RE: Phase II Athletics - **Change Order 08 – Structural and Wall Revisions**

PROJECT: *(Name and address)*
Phase II Athletics - Bid Package No. 2 -
NB Field House
Bullitt County Public Schools

CHANGE ORDER INFORMATION:
Change Order Number: 08

① EXTERIOR HM DOOR FRAME- HEAD- 4" FRAME w/ MASONRY LINTEL
 3" = 1'-0"

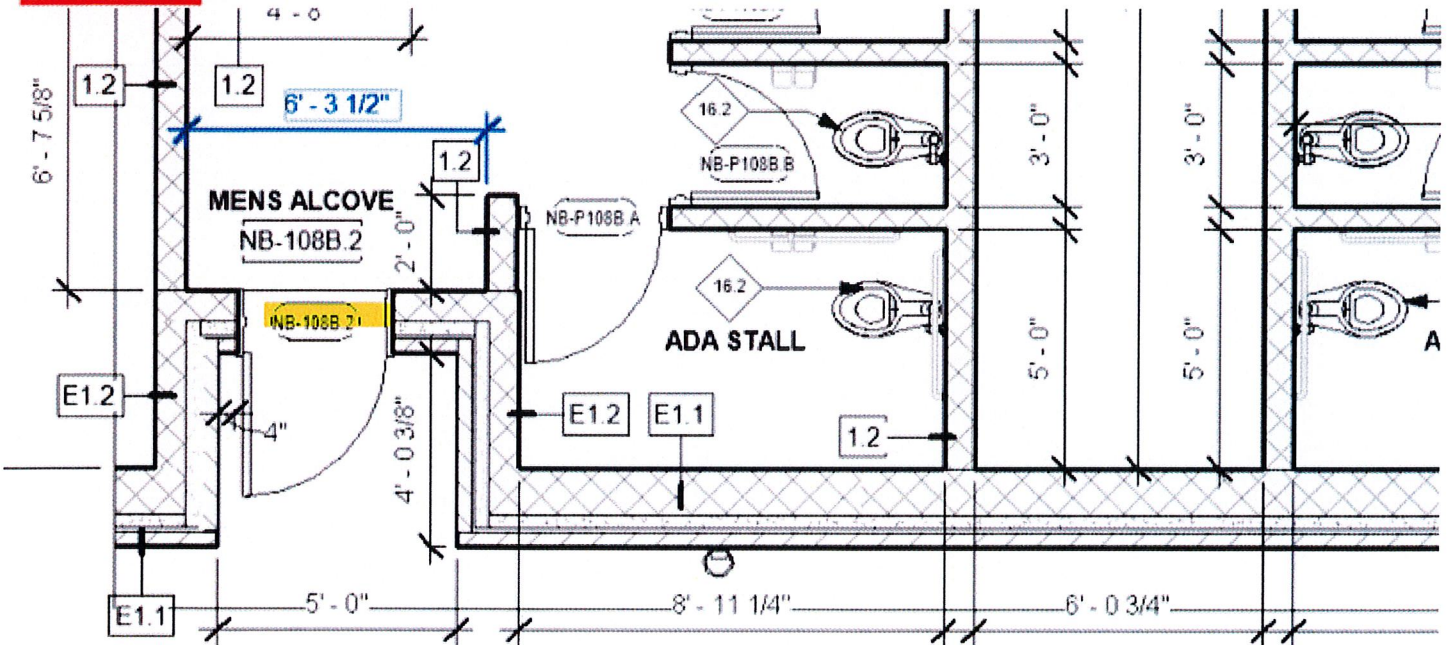
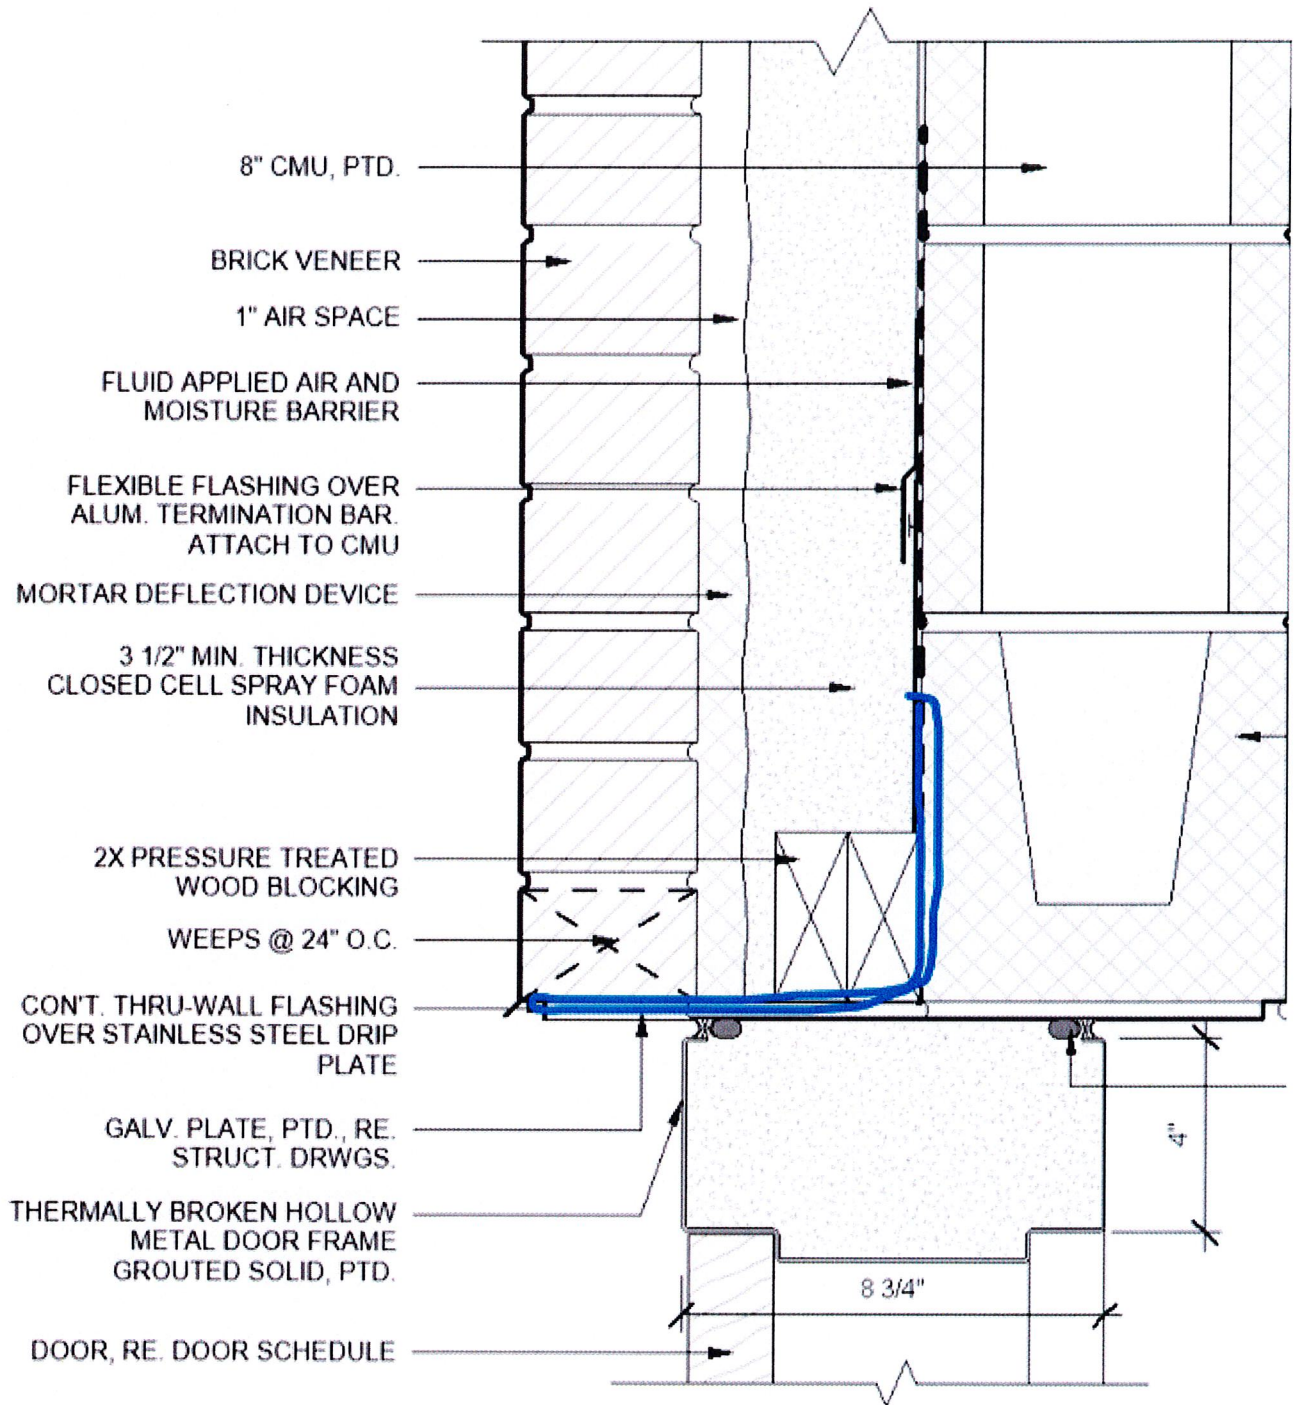
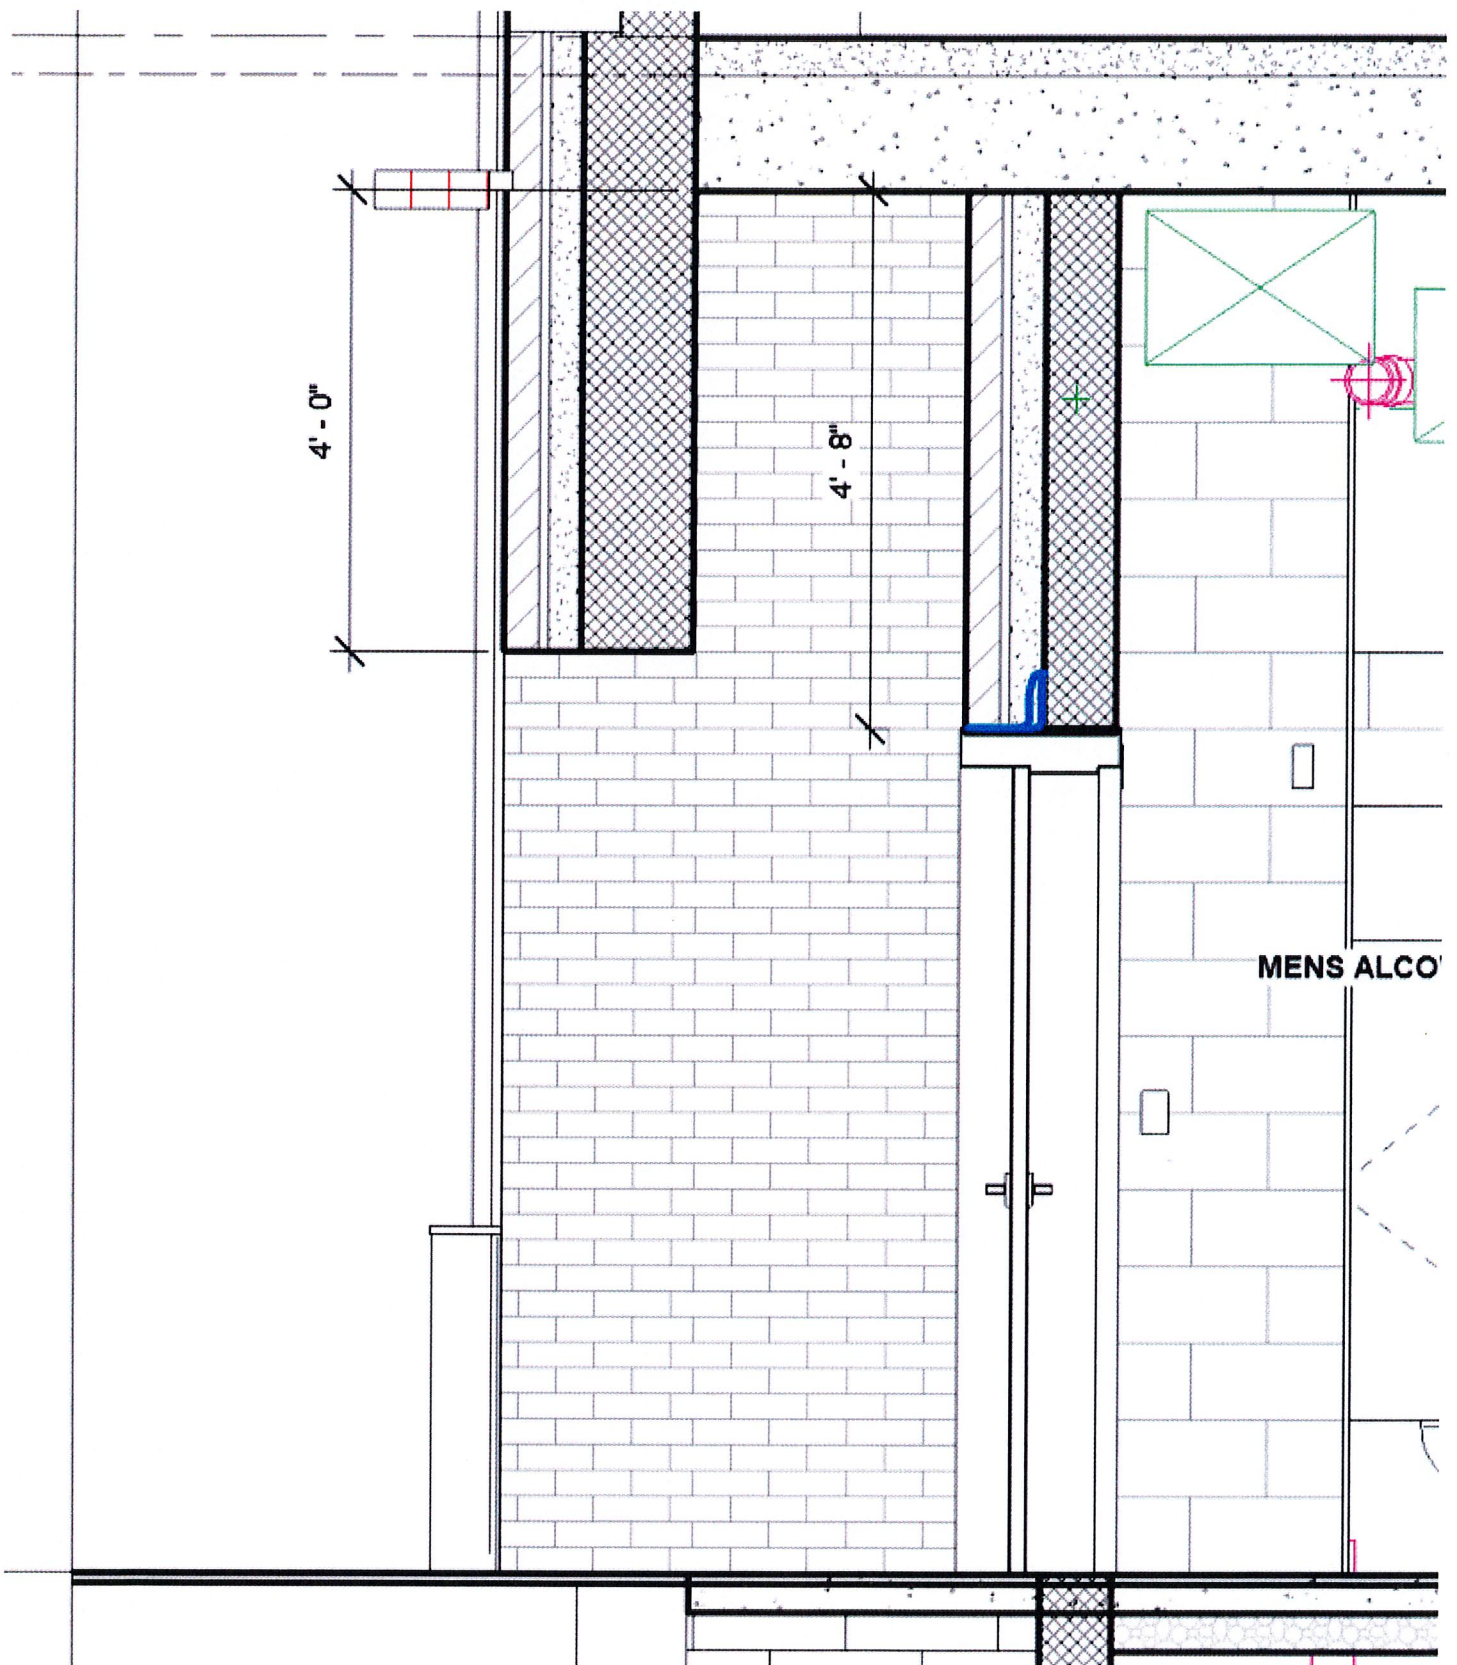
Can you take a look at the mark-ups to my architectural door detail, below, and see if a steel angle can be used in lieu of a continuous plate to support the brick veneer above doors 108B.1 and 108A.1 (Public Restroom exterior Alcoves). The angle would be supporting 4'-8" height of brick veneer (section is provided below).

We have an issue with routing access controls above these doors due to the continuous plate.

Grant, per our conversation, we need an L5x3 1/2x5/16 at this location. Galvanized, and to be installed per the General Notes.

For a masonry lintel, the brick support should be selected from our loose lintel schedule. In this case, a 3'-4" door opening should have a L3 1/2x3 1/2x5/16 angle. This will be installed like you have shown in blue below, but the vertical leg will likely butt up to the inside face of brick.

① EXTERIOR HM DOOR FRAME- HEAD- 4" FRAME w/ MASONRY LINTEL
 3" = 1'-0"

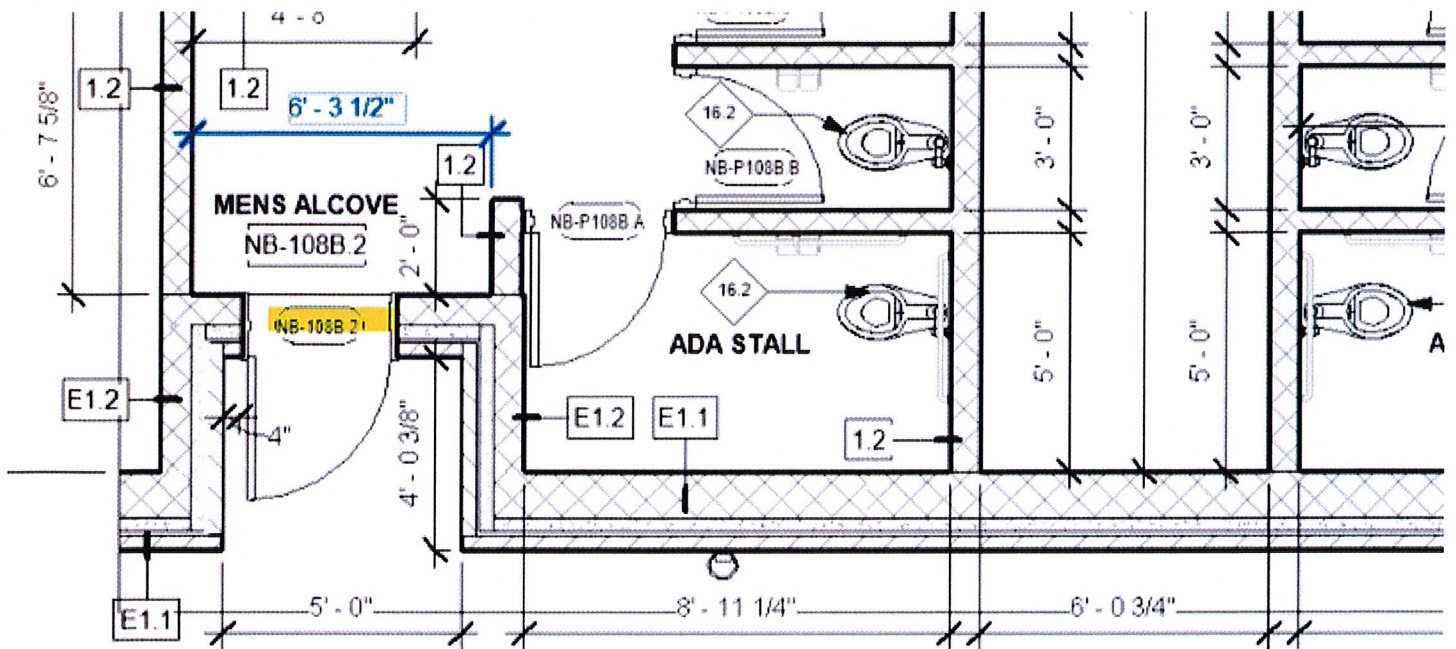
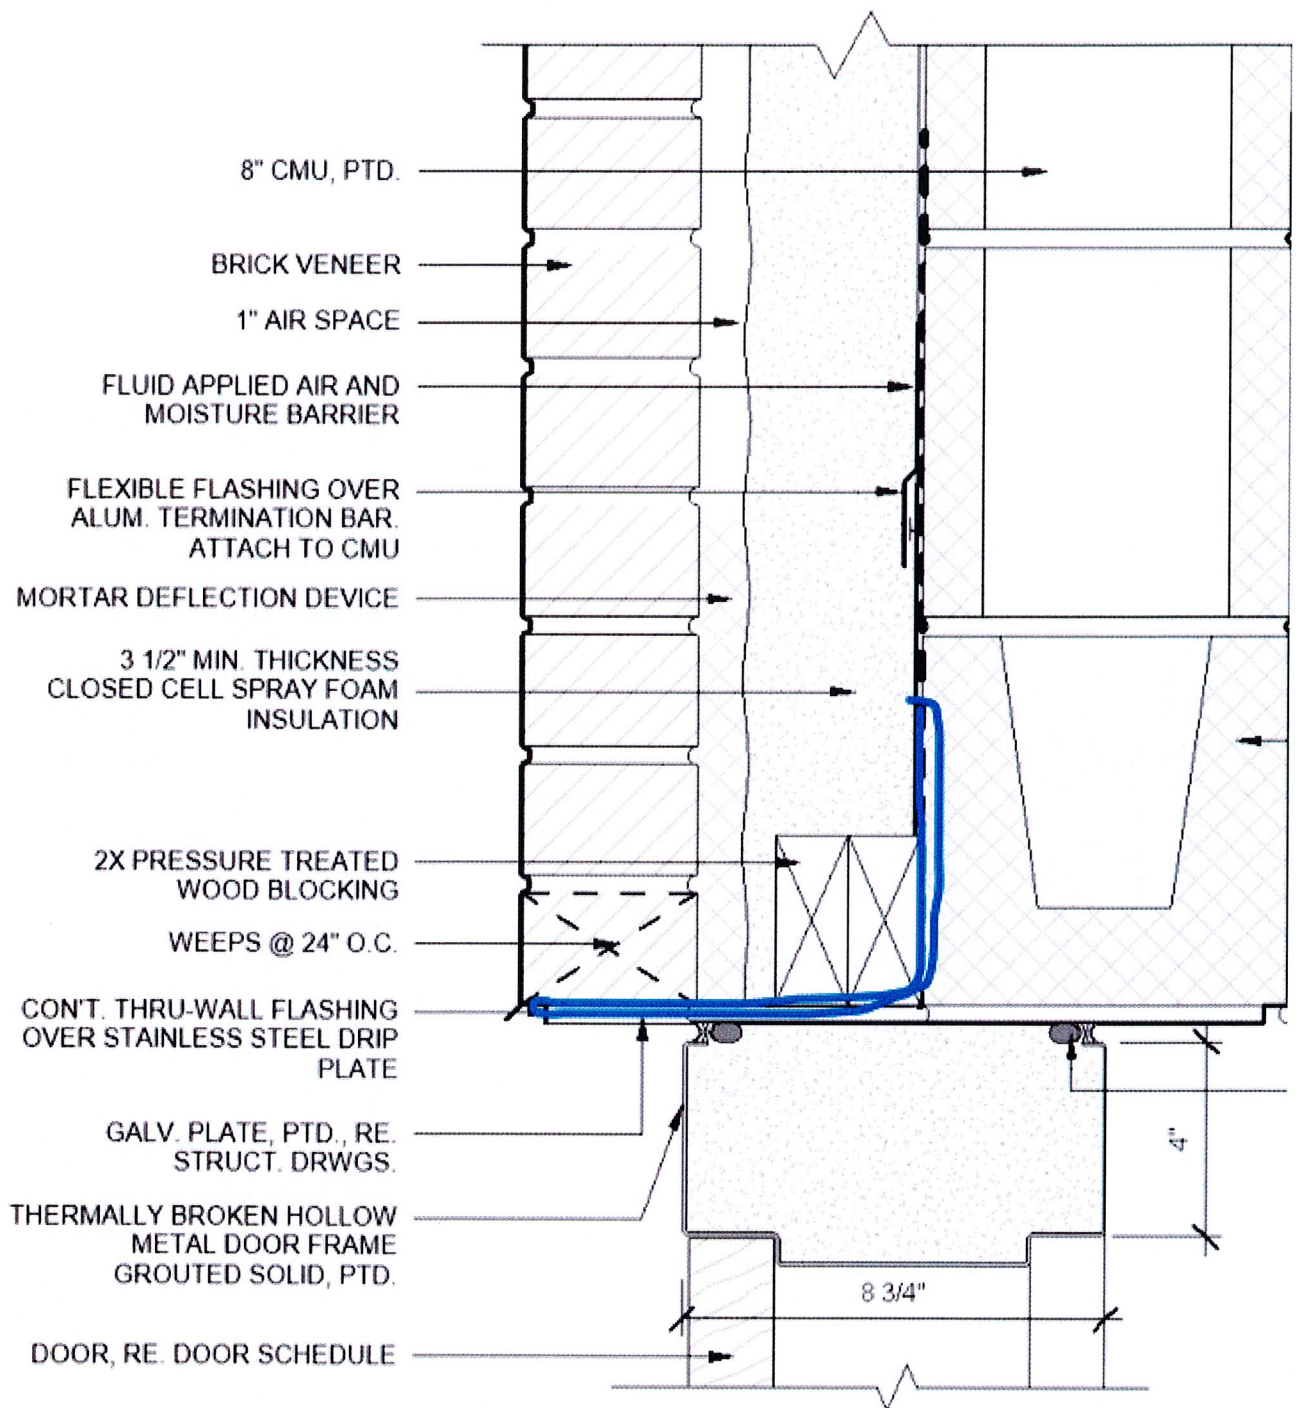
Can you take a look at the mark-ups to my architectural door detail, below, and see if a steel angle can be used in lieu of a continuous plate to support the brick veneer above doors 108B.1 and 108A.1 (Public Restroom exterior Alcoves). The angle would be supporting 4'-8" height of brick veneer (section is provided below).

We have an issue with routing access controls above these doors due to the continuous plate.
